FORD E40D

VALVE BODY, SPACER PLATE, SPACER PLATE GASKETS, CHECKBALL LOCATIONS, AND CASE CHANGES, FOR THE 1996 MODEL YEAR

96-28

1989 - 1995 VALVE BODY CHECKBALL LOCATIONS 2 - 5/16 RUBBER BALLS ALL MODELS

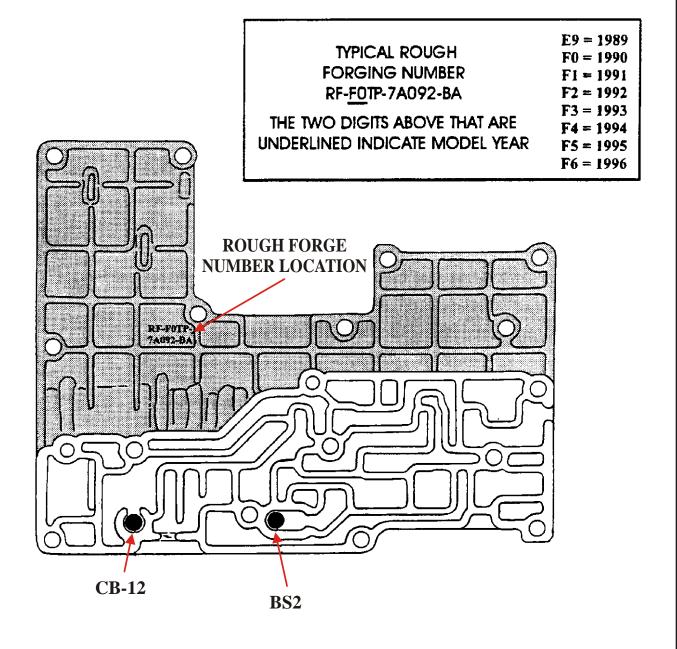
((1) VALVE BODY CHECKBALL LOCATIONS - Have remained the same for 1989 thru 1995 model years, with TWO 5/16" rubber checkballs, and their locations are shown in Figure 1. Beginning in the 1996 model year there are FIVE checkballs in the main valve body and their locations are shown in Figure 2. Notice that there are two 5/16" rubber balls and three 1/4" rubber balls. The 1/4" rubber balls are green in color (See Figure 2).

Figure 3

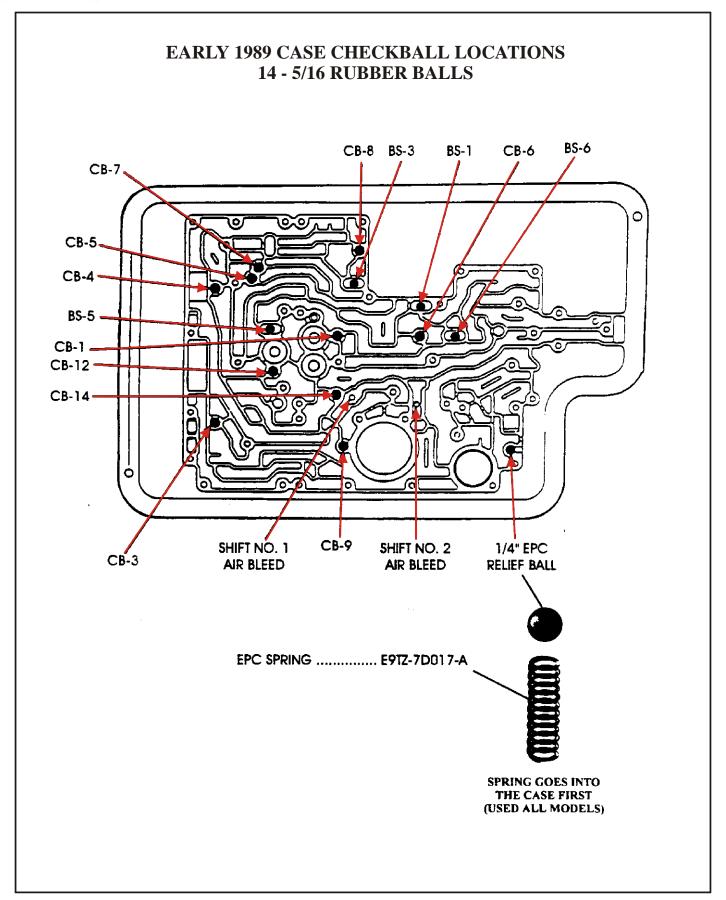
Early 1989 Models - Requires Fourteen 5/16" checkballs in the case, in the locations shown in Figure 3, and uses a l/4" steel ball for the EPC blow-off, and location is shown in Figure 3.

Figure 4

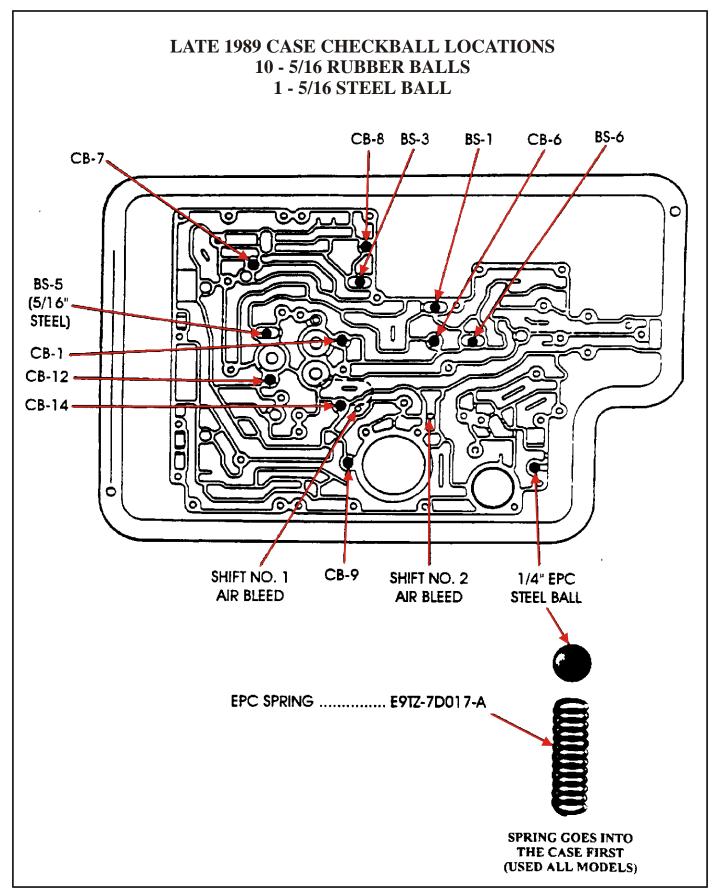
Late 1989 Model - Requires Ten 5/16" rubber checkballs, and One 5/16" diameter steel checkball, for a total of Eleven, in the locations shown in Figure 4, and uses a l/4" steel ball for the EPC blow-off, and the location is shown in Figure 4.

Figure 5

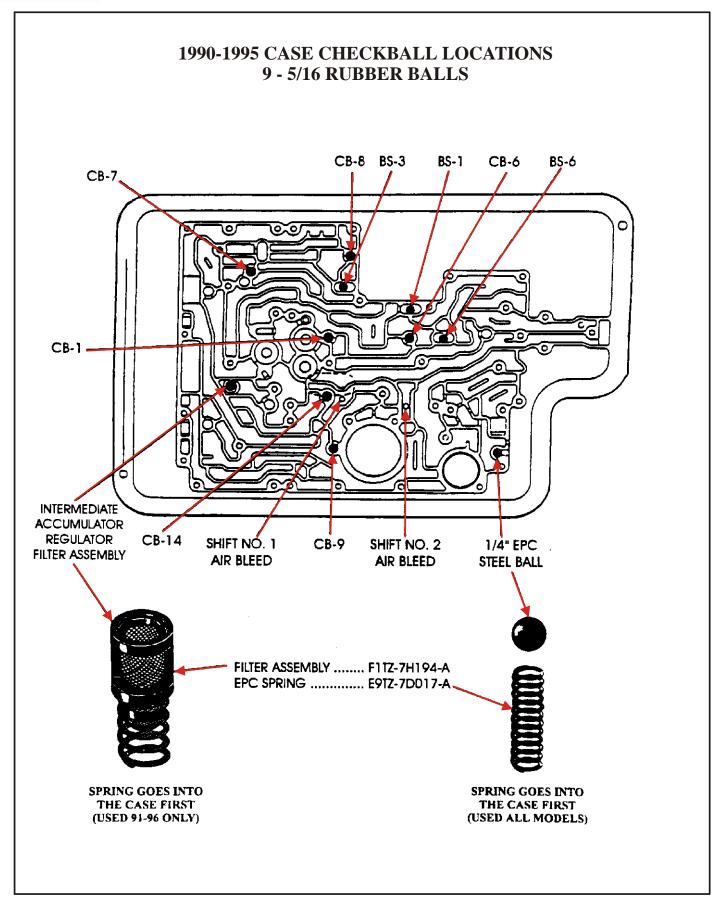
All 1990-1995 Models - Requires Nine S/16" rubber checkballs in the case, in the locations shown in Figure 5, and uses a l/4" steel ball for the EPC blow-off, and the location is shown in Figure 5. Beginning in 1991 there is an added Intermediate Accumulator Regulator Filter Assembly, and the location in the case is shown in Figure 5

Figure 6

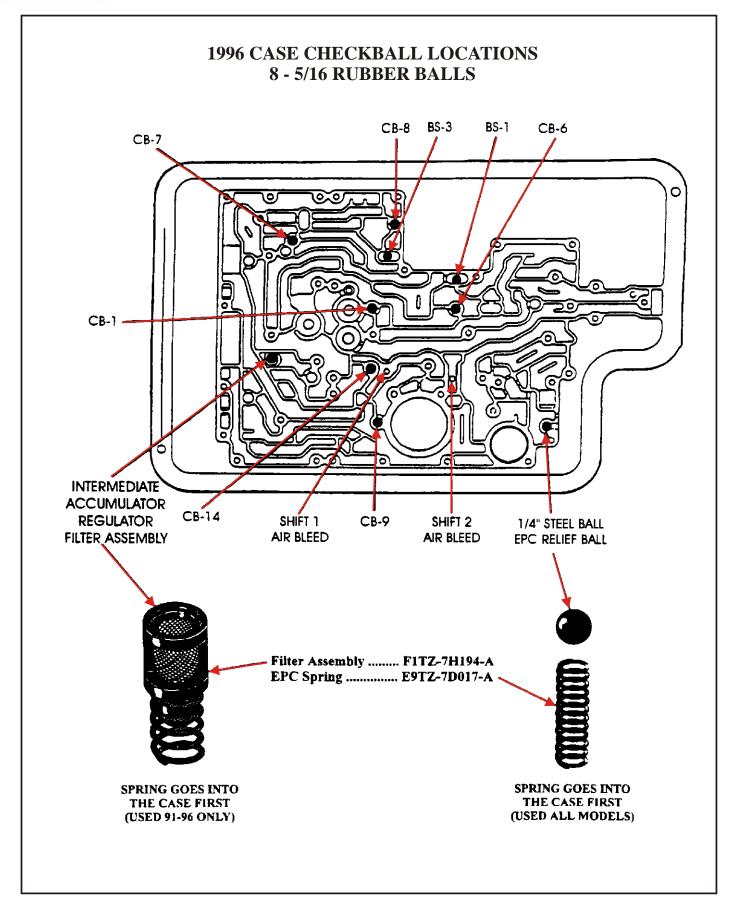
All 1996-W Models - Requires Eight 5/16" rubber checkballs in the case, in the locations shown in Figure 6, and uses a l/4" steel ball for the EPC blow-off, and the location is shown in Figure 6.

Figure 8

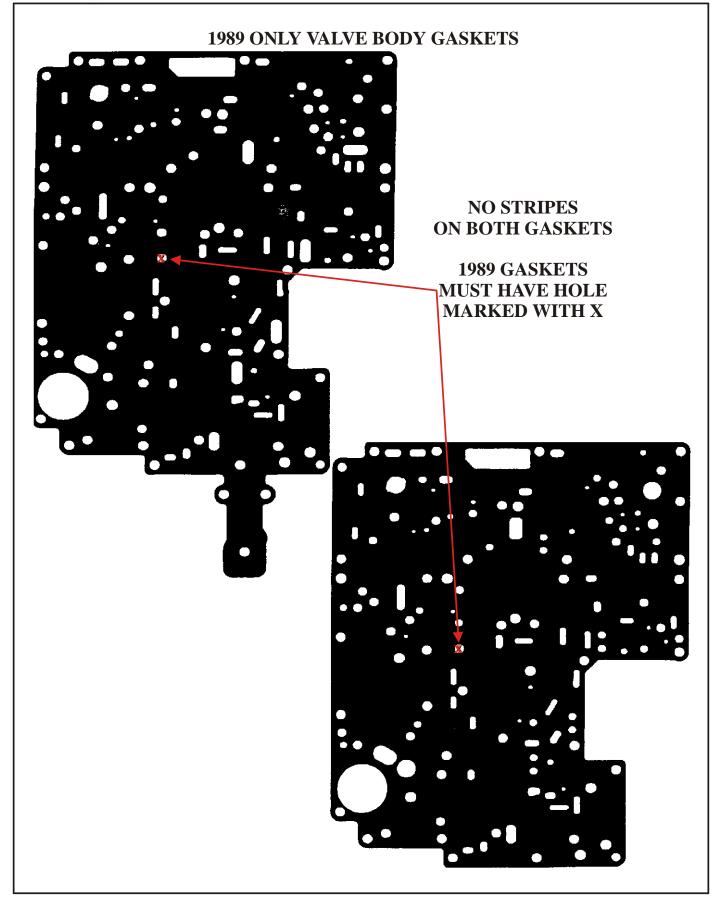
(3) SPACER PLATE GASKETS - Have changed twice since the introduction in 1989. 1989 Models Only - Require the Spacer Plate Gaskets with solenoid feed hole (Marked X) in the location shown in Figure 8, and the gaskets have N? I.D. stripes on either gasket. 90-95 Models Only - Require the Spacer Plate Gaskets with solenoid feed hole (Marked X) in the location shown in Figure 9, and both gaskets have Yellow I.D. Stripes 96-UP Models Only - Require the Spacer Plate Gaskets with Green I.D. stripes on both gaskets. These gaskets have a multitude of hole location differences, as shown in Figure 10.

Figure 12

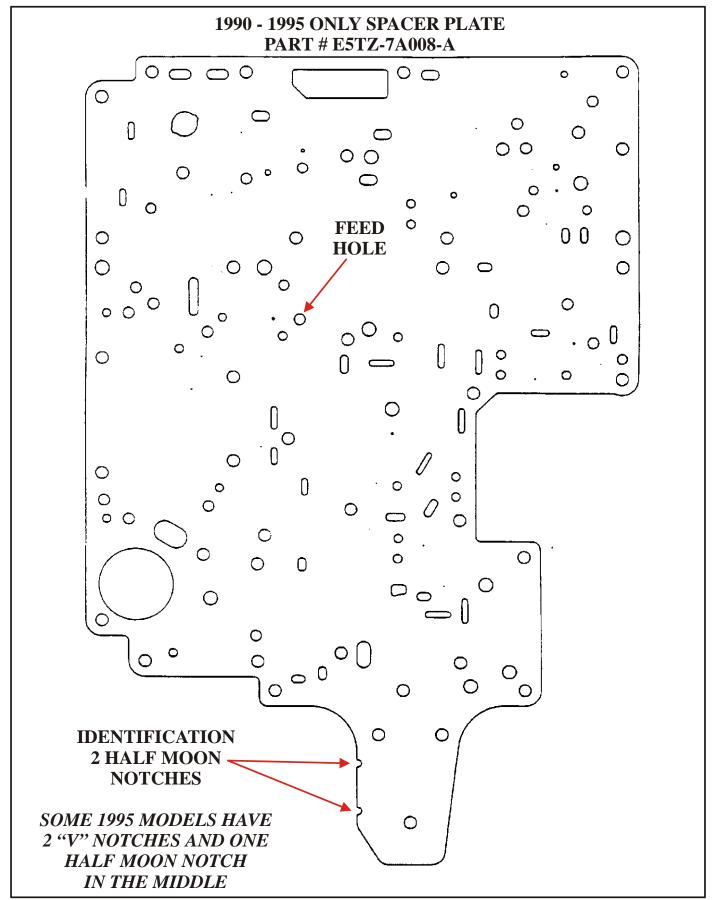
90-95 Models only - Requires the Spacer Plate with the solenoid feed hole in the location shown in Figure 12, and has two "Half Moon" notches for identification. Note; Some models have two "V" notches with one "Half Moon" notch between them for identification.

Figure 13

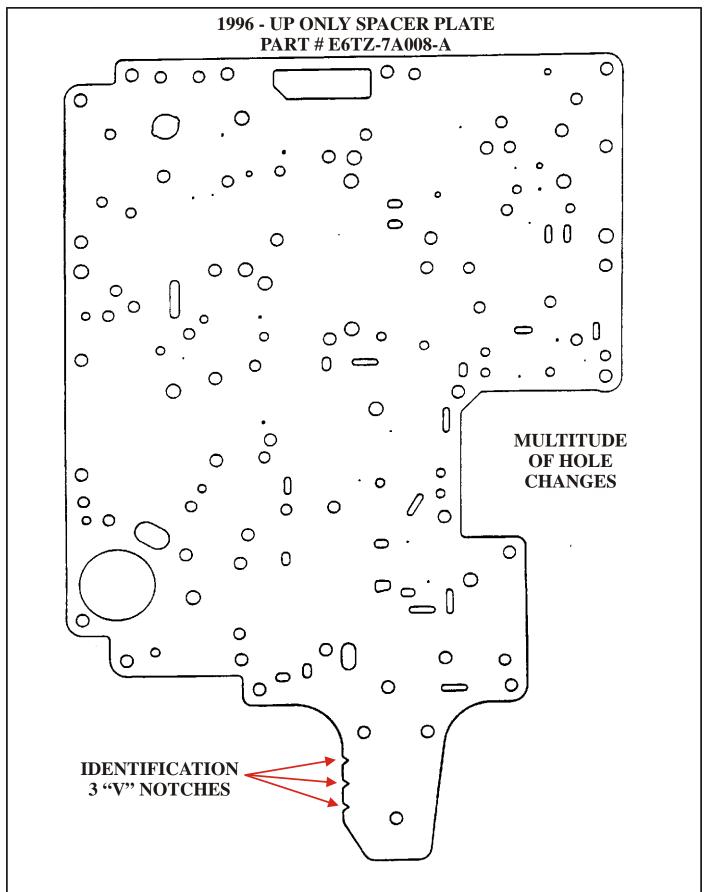
1996-W Models Only - Requires the Spacer Plate with the three "V" notches for identification as shown in Figure 13, and has a multitude of hole location changes.

Figure 14

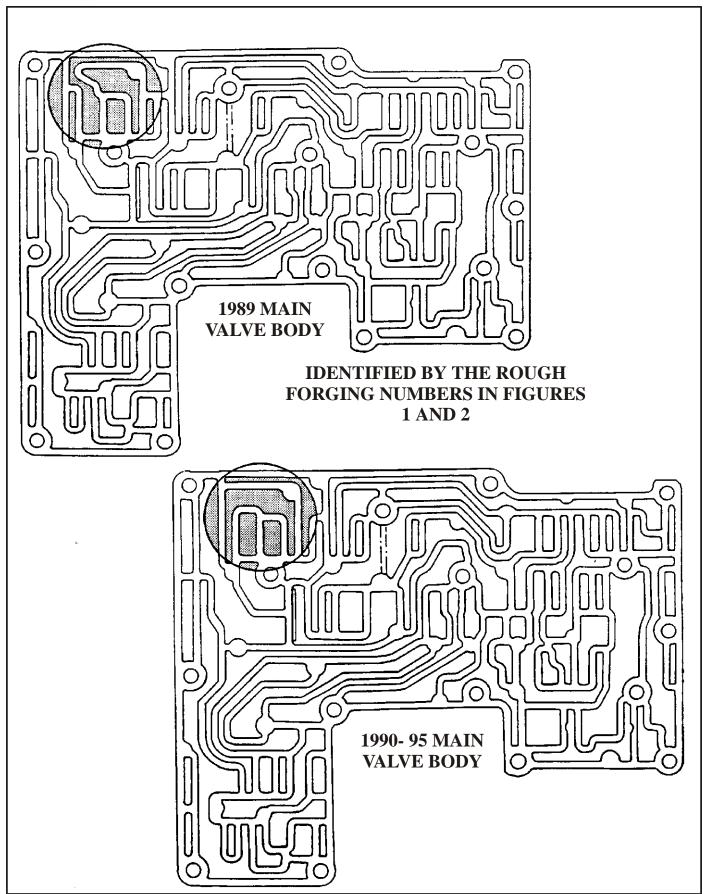
1989 Models Only - Can be identified by the differences in the worm track area at the 1-2 shift valve, as shown inside the circles in Figure 14. The best, and most accurate method to identify the valve body, is the rough forging number cast into the valve body in the location shown in Figures 1 and 2.

90-95 Models only - Can be identified by the differences in the worm track area at the 1-2 shift valve, as shown inside the circles in Figure 14. The best, and most accurate method to identify the valve body, is the rough forging number cast into the valve body in the location shown in Figures 1 and 2.

Figure 16

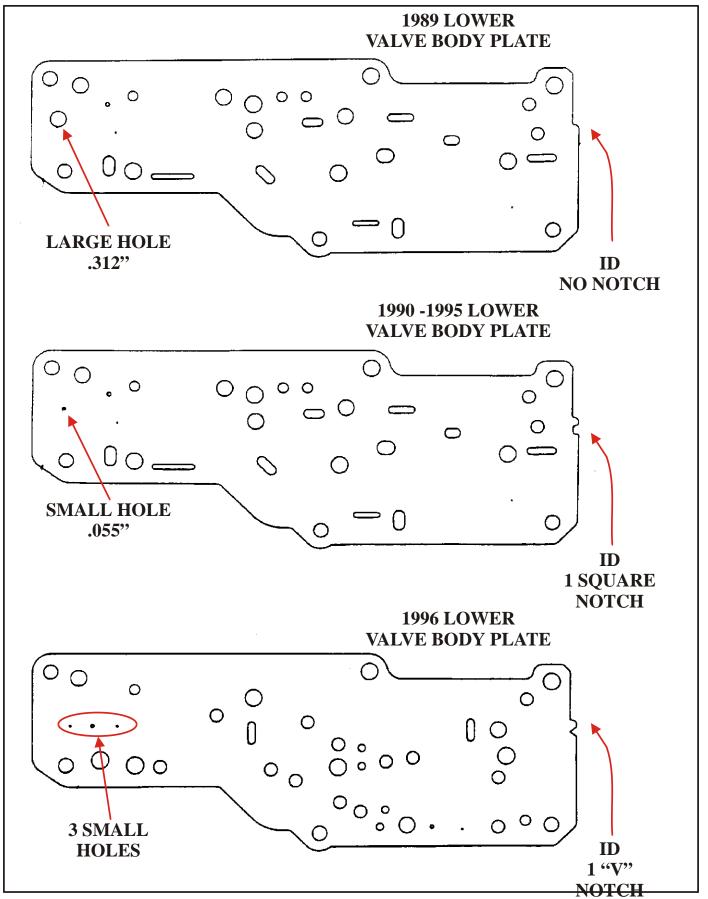
(6) LOWER VALVE BODY SPACER PLATE - Can be identified by the diameter of the feed hole in the location shown in Figure 16. For 1989 models the hole diameter is .3 12", and for 90-95 models the hole diameter is .055".

The 1996-Up models have three small holes in this location, as shown in Figure 16, and a multitude of hole location differences to accommodate the added valve body checkballs.
